**SPECIALIST OPINION – ADDENDUM TO NOISE IMPACT ASSESSMENT: CHANGES TO THE LAYOUT OF THE FE HUGO WIND ENERGY FACILITY**

The above-mentioned issue as well as the Environmental Noise Impact Assessment report, ref.: ERM-HWEF/ENIA/202405-Rev 2 dated May 2024 is of relevance.

Figure 2: New proposed WTG layout (2024 – 05 - 27)

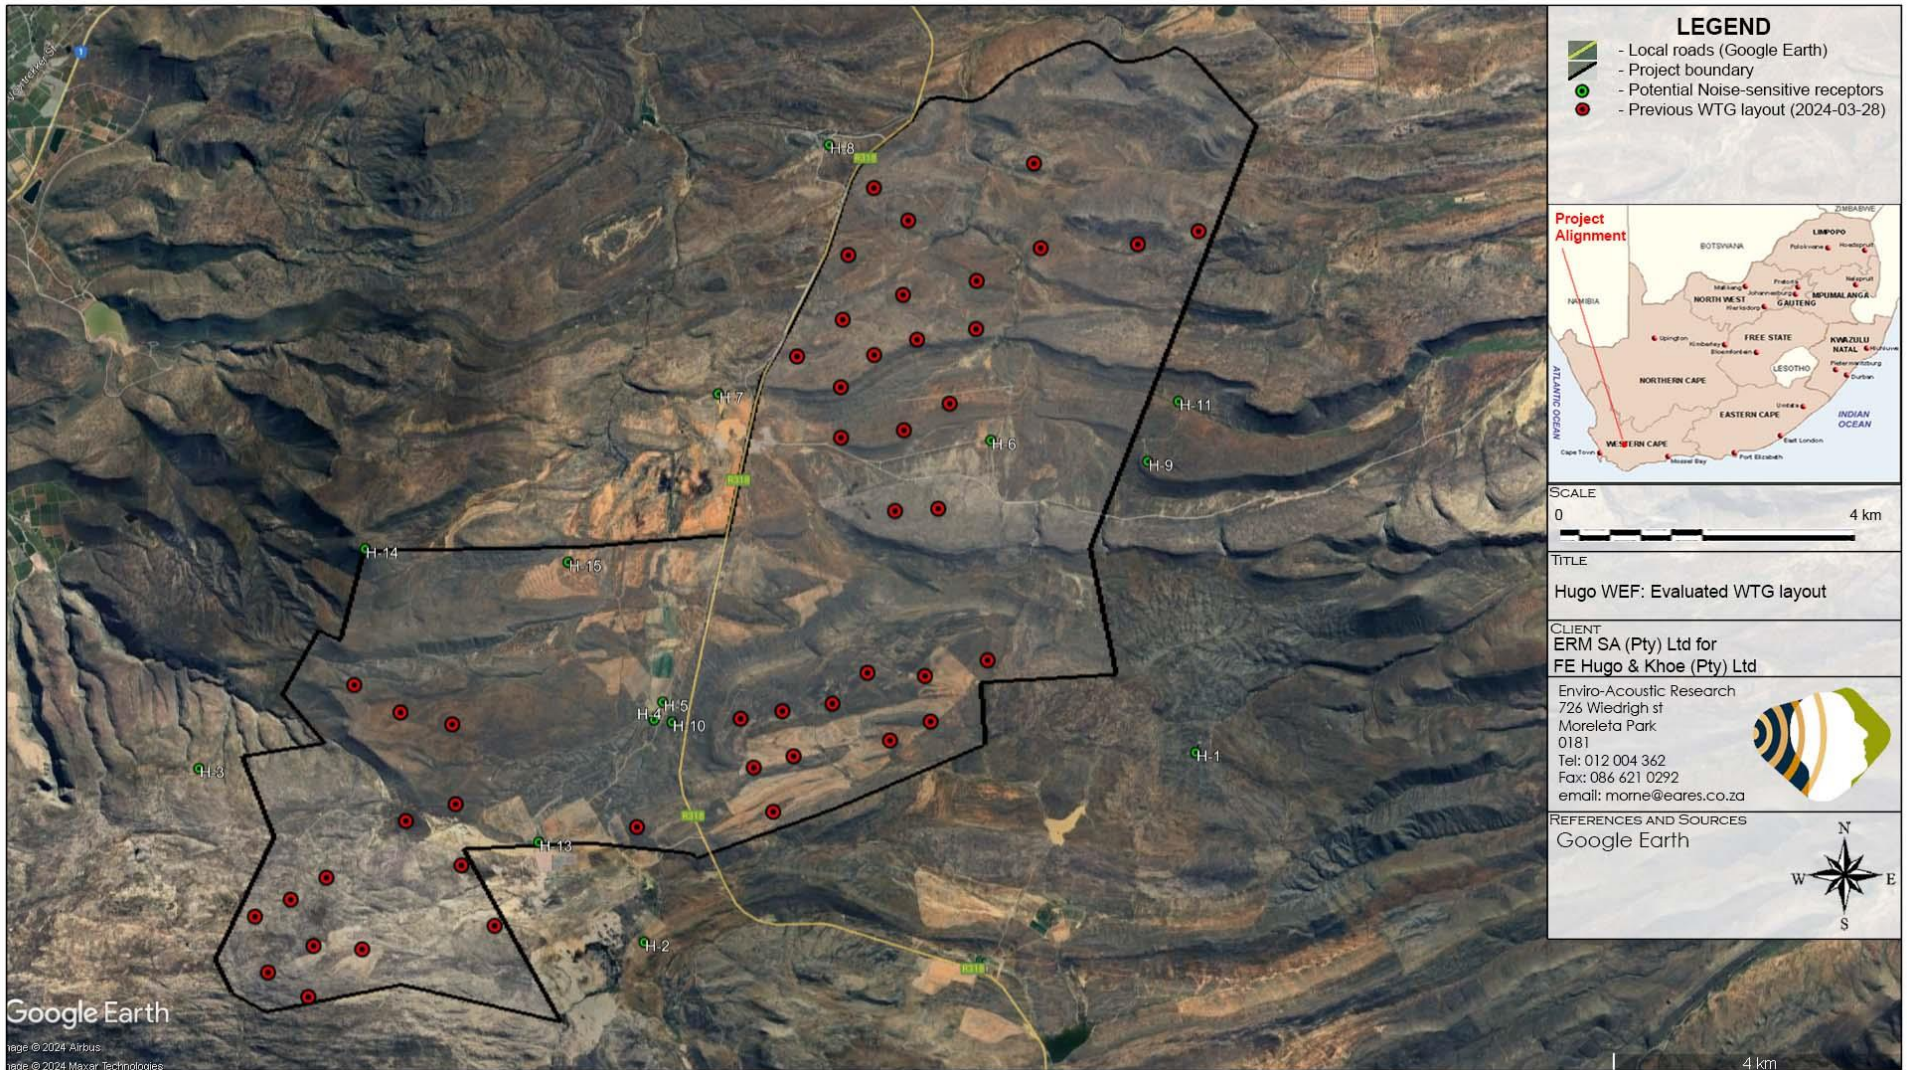
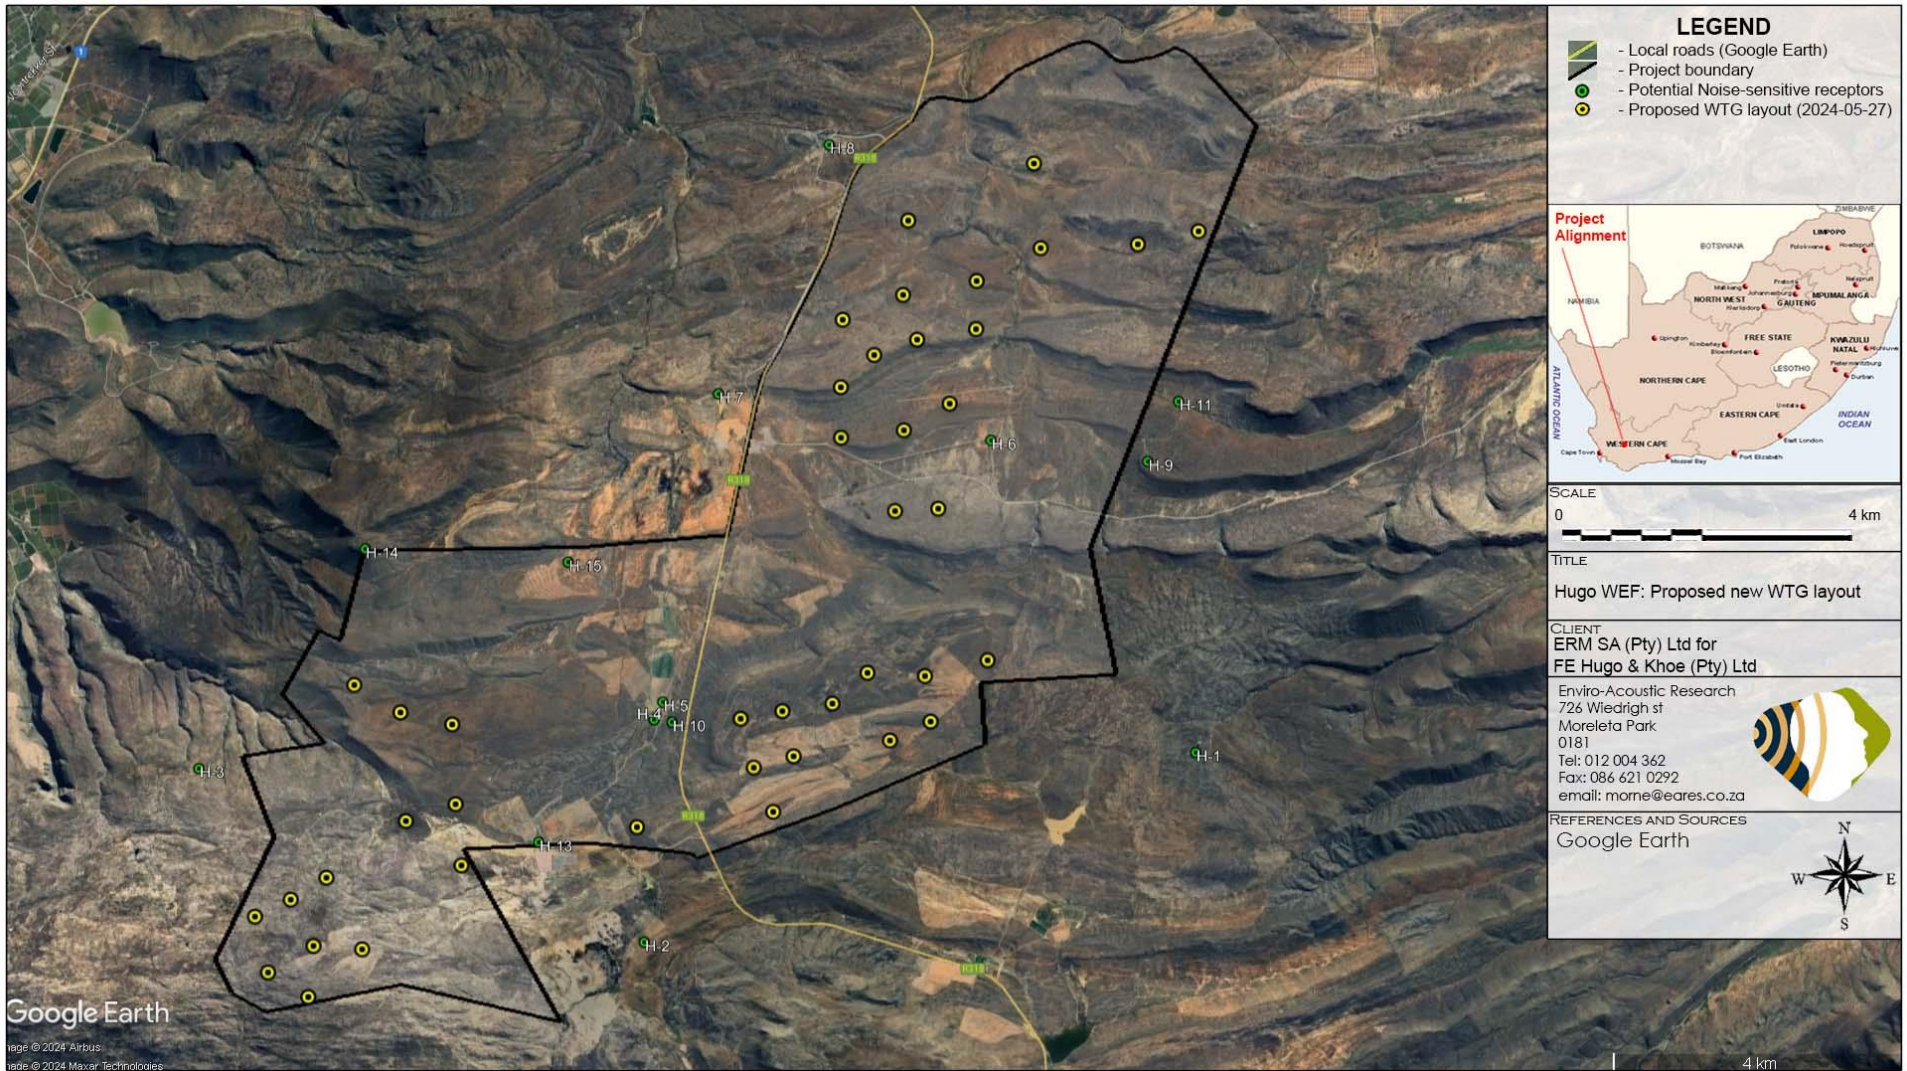
Considering the feedback and findings of various specialist studies, the client updated the layout, only eliminating a number of WTG. The proposed layout is depicted in Figure 2. Considering the latest layout:

- There are two less WTG within 2,500m from NSR H-8 which will result in a definite and significant reduction (a reduction of at least 3 dBA) in noise levels at this NSR. This will not change the findings of the noise study;
- There is one less WTG within 2,500m from NSR H-7 which will result in a definite and significant reduction (a reduction of at least 3 dBA) in noise levels at this NSR. This will not change the findings of the noise study; and
- There is one less WTG within 2,500m from NSRs H-3, which will result in a minor reduction in noise levels at these NSR. This will not change the findings of the noise study.

Therefore, the changes in the layout are minor in terms of acoustics, and while it may result in a reduction in noise levels at NSRs H-2, H-7, H-8 and H-13; these changes in noise levels will be minor and will not result in a change of the findings or recommendations of the May 2024 Noise Study. No additional acoustic studies would be required and the findings and recommendations of the May 2024 Noise Study for FE Hugo WEF should remain as recommended.
